Date: December 23, 2019

**ADDENDUM NO. 2**
To Project Bidding Documents for:

**A#03-119686**
**New Student Services Building**
**Compton Community College District**

tBP Project. No. 20987.00

CODE ANALYSIS FIRST FLOOR 1
SCALE1/16" = 1'-0"

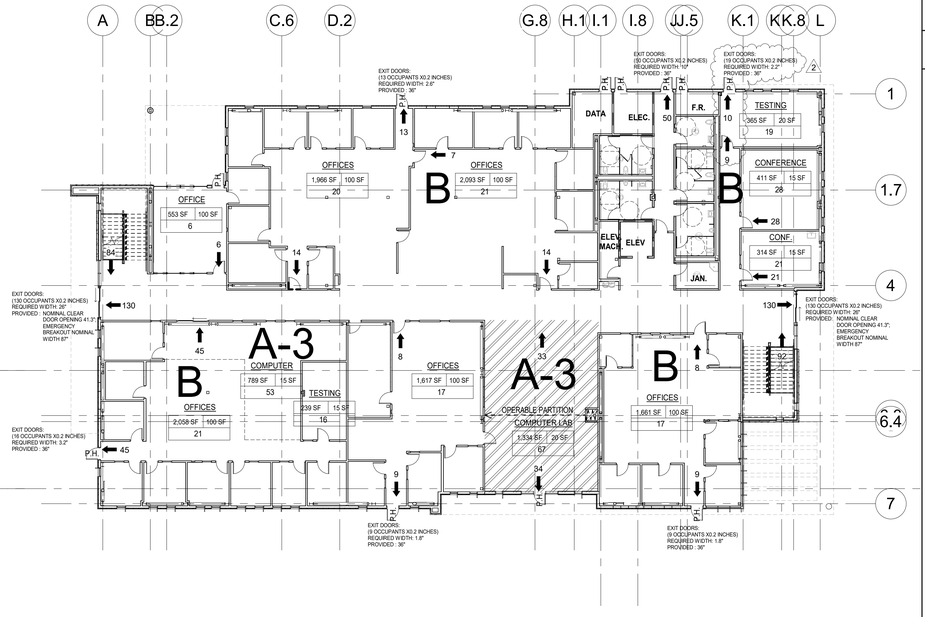
a. Revised door swing on exit door from conference to testing and modified exit width tabulations for exterior exit door on Code Analysis First Floor Plan No. 1.

**C1.2**

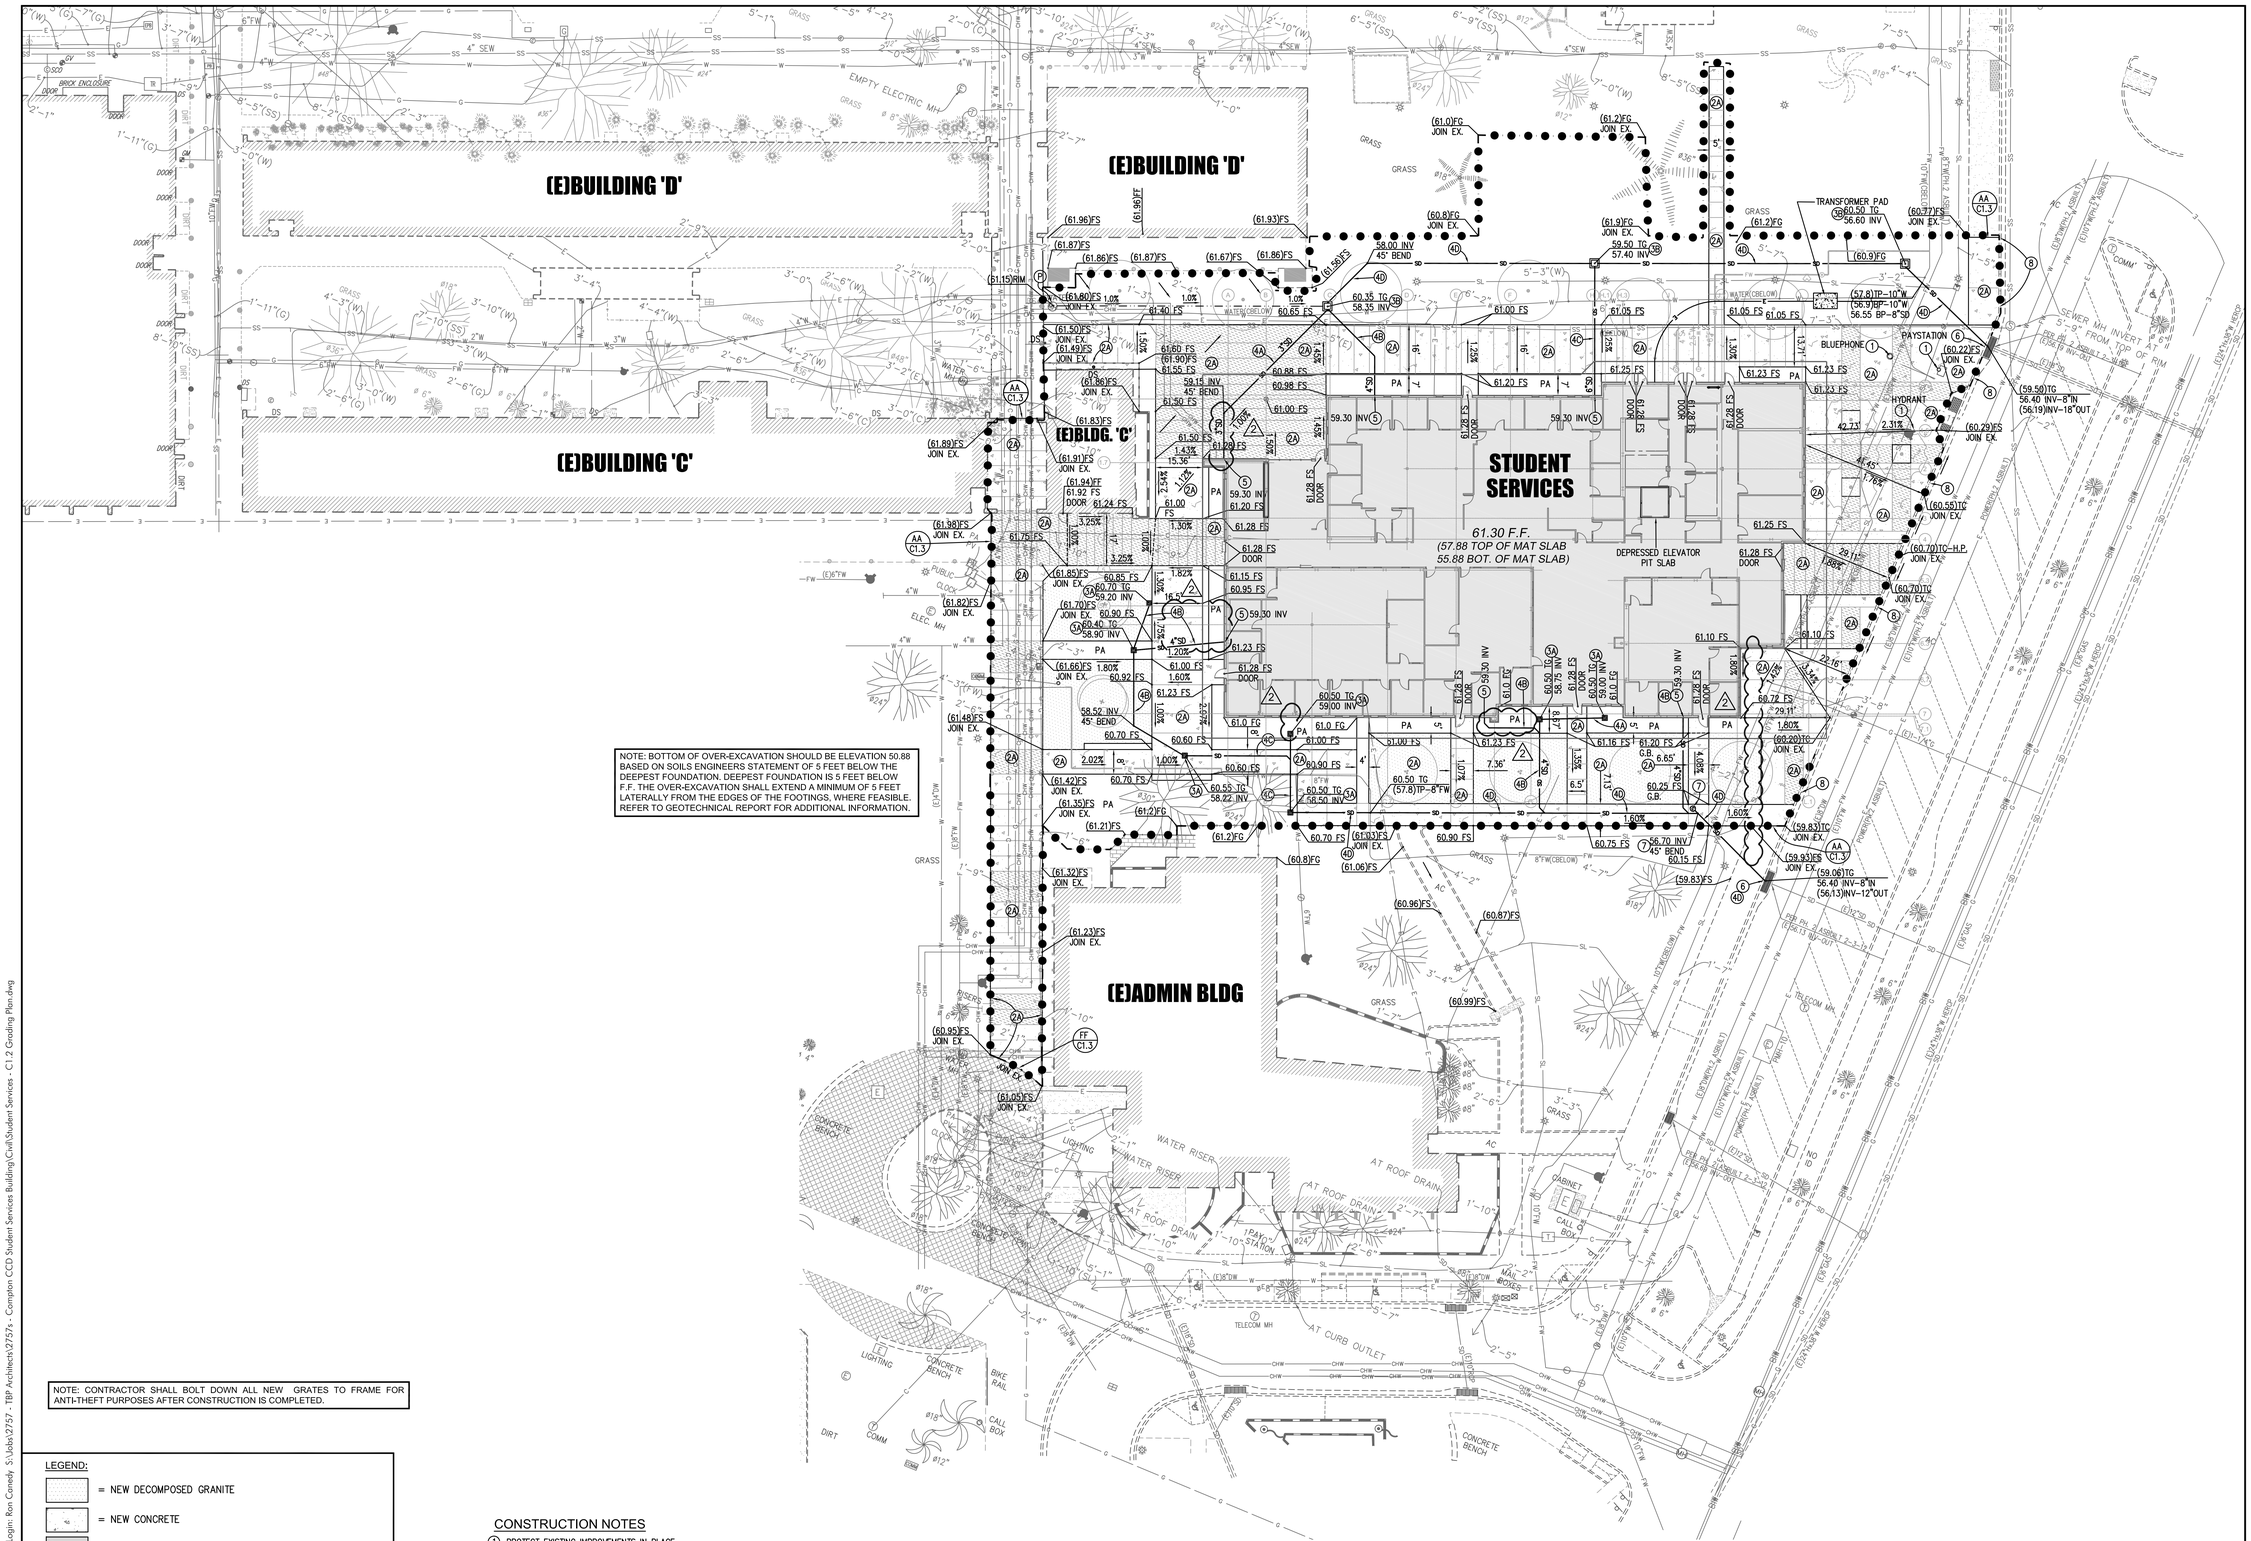
a. Revised Roof Drain connections to building SS building.

SITE DEMOLITION PLAN

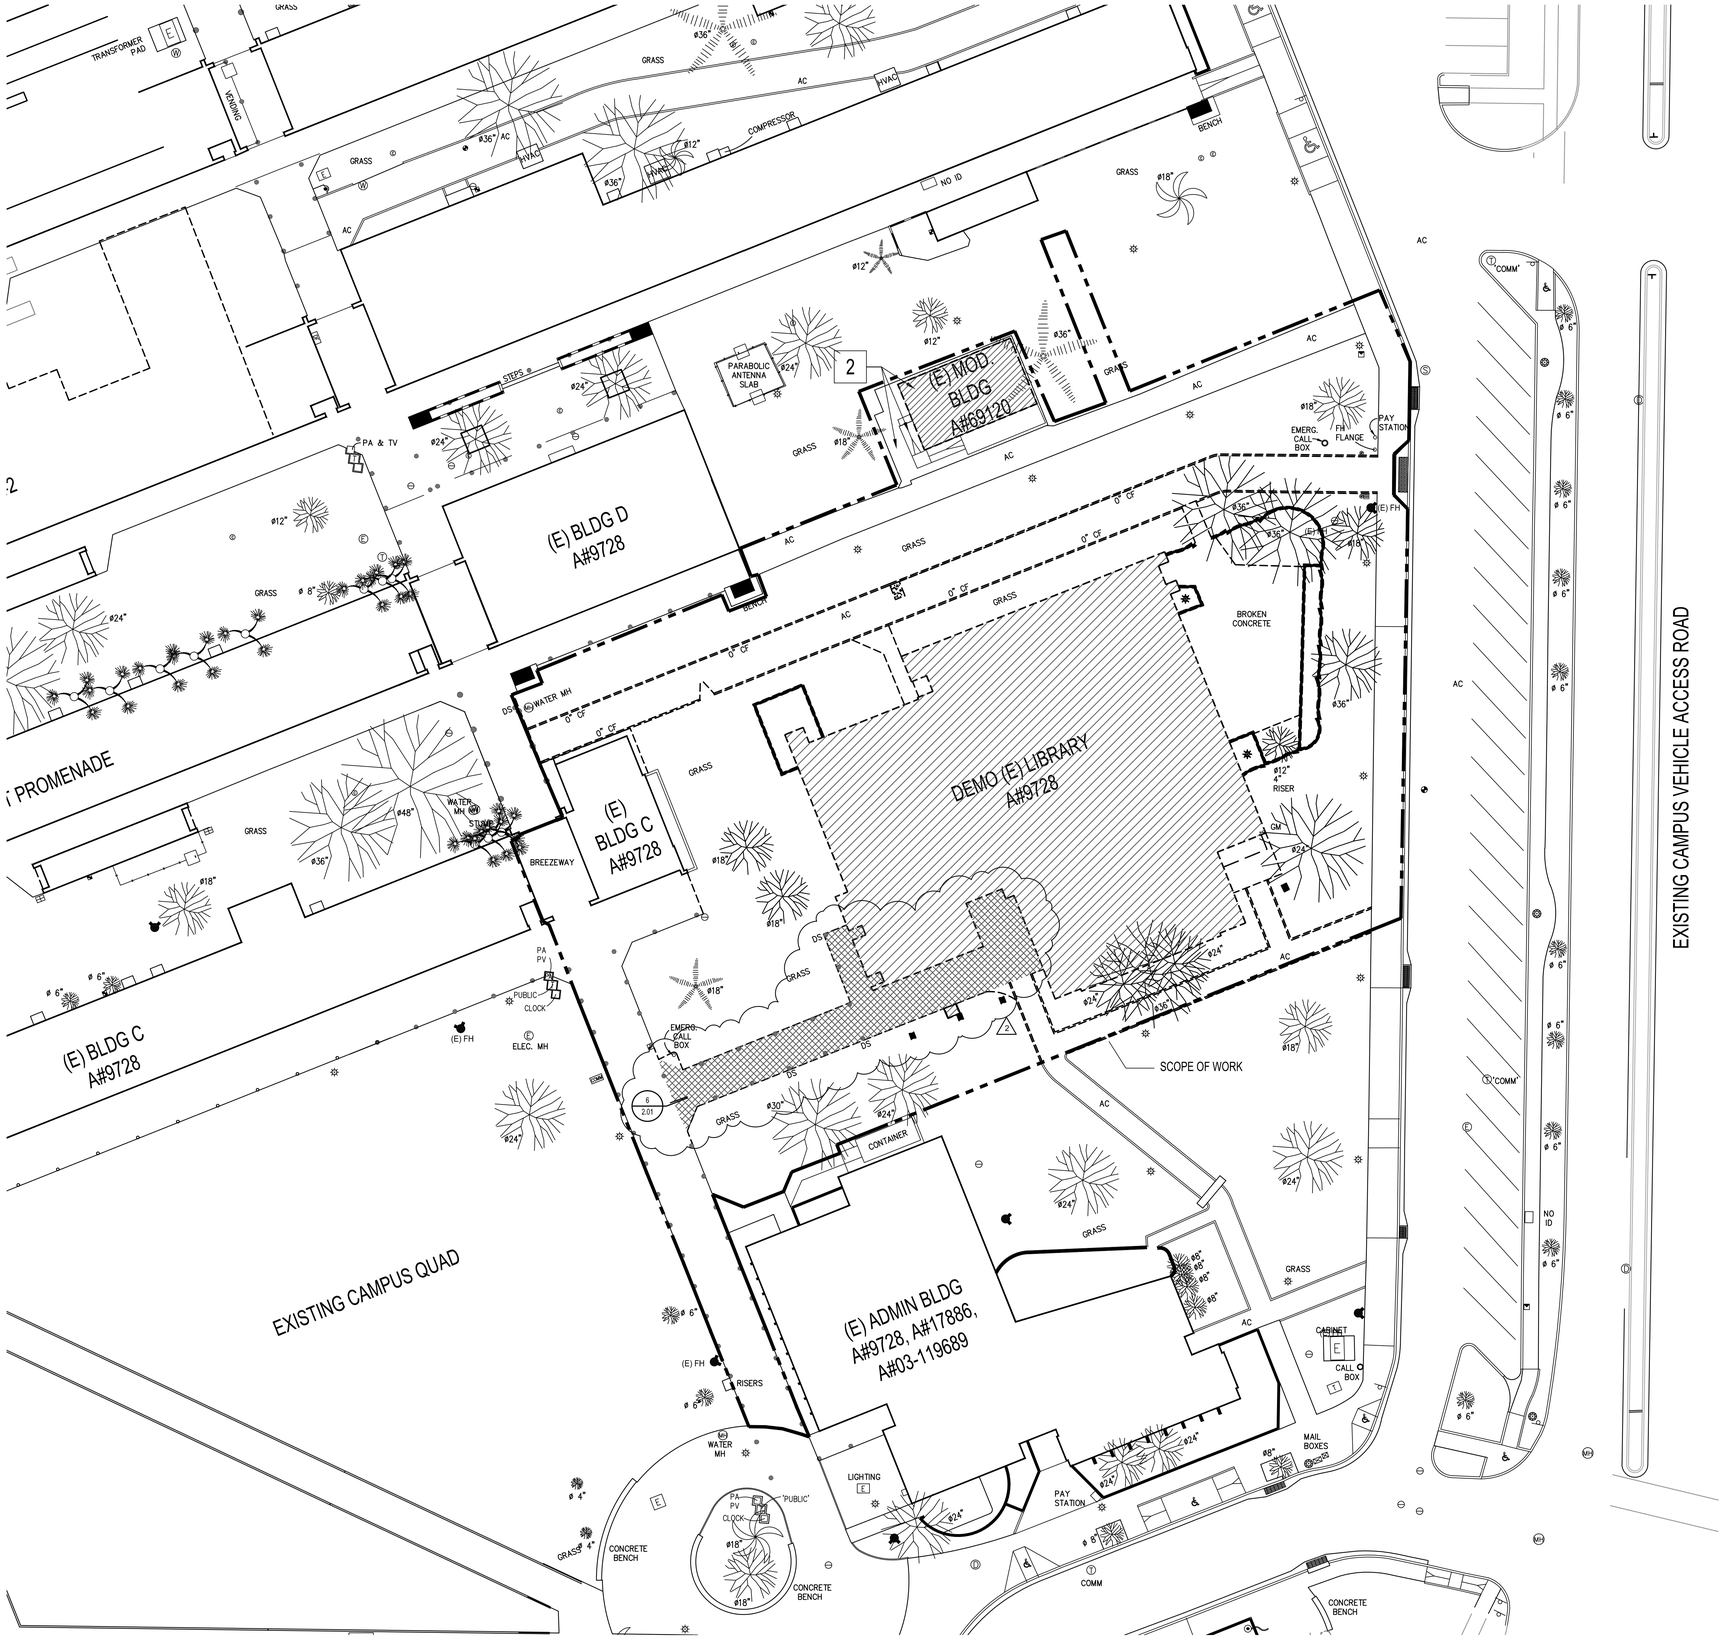
a. Partial canopy demolished at (E) Library.
    b. Added Detail Reference.

2ND FLOOR CURB/DEPRESSION PLAN 1

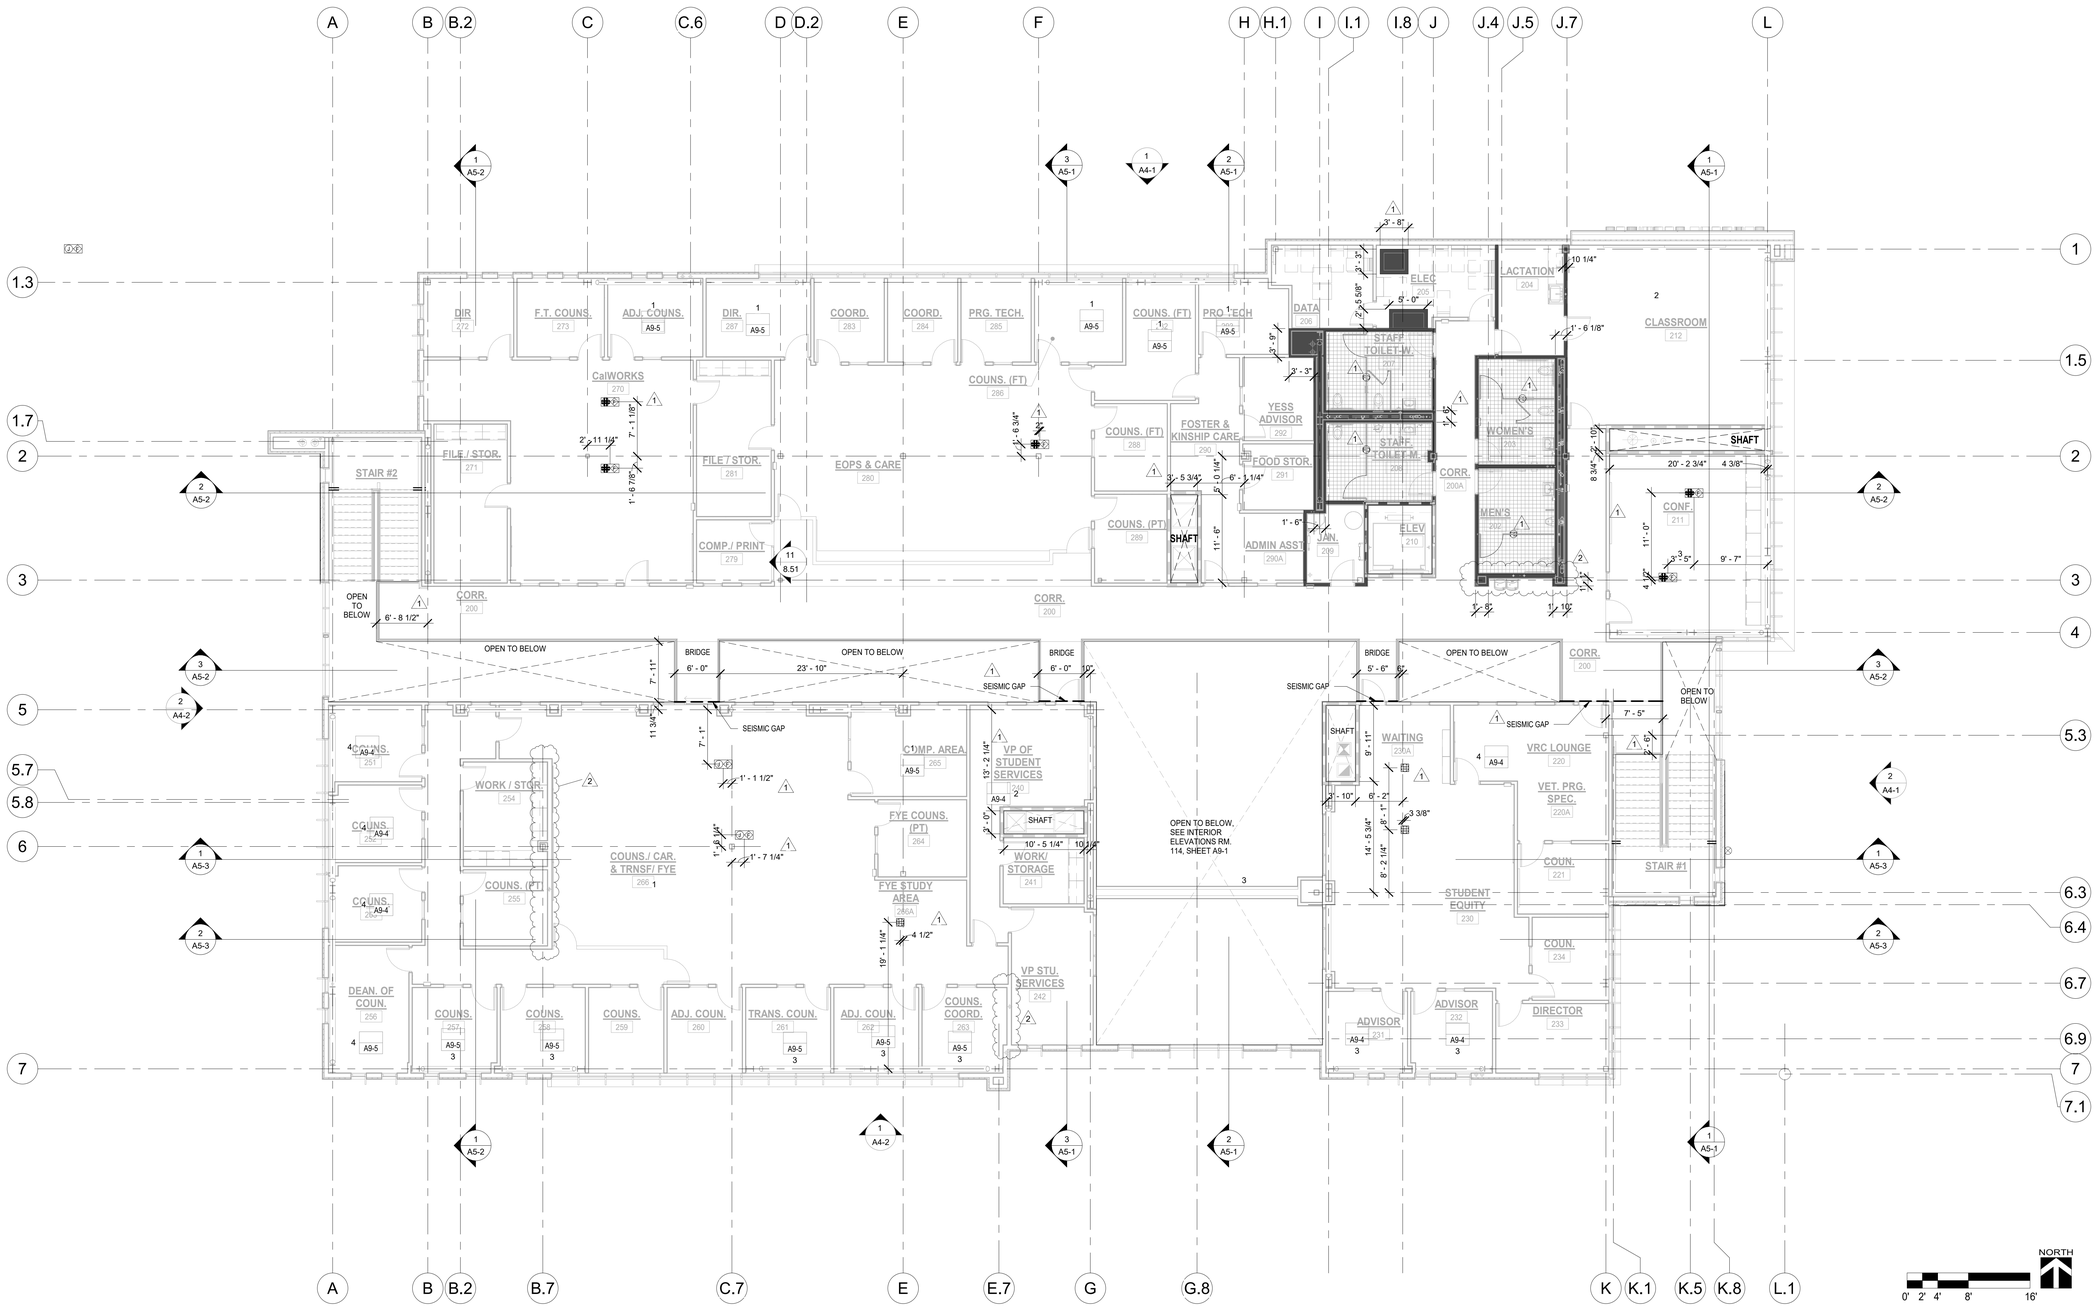
a. Revised wall stud width to 6-Inch stud at drinking fountain in room 200. Adjust curb width accordingly to correspond with stud width.
    b. Revised wall stud width to 6-inch at East wall of room 263.
    c. Revised wall stud width to 6-inch at East wall of rooms 254 & 255.
